American Telecommunications Certification Body Inc.
6731 Whittier Ave, McLean, VA 22101

RE: Proxim Corporation

FCC ID: HZB-4000LR

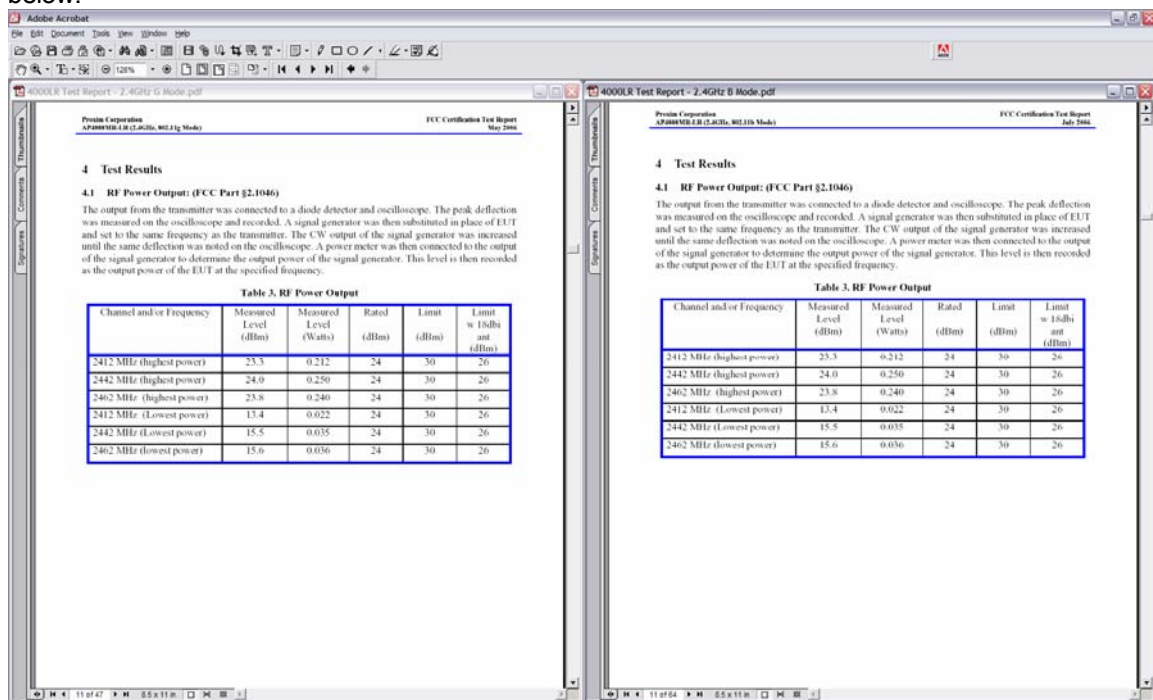
- 1) Previous response to 3 appears inconsistent with 2 most recent 802.11b/g reports provided. See below:
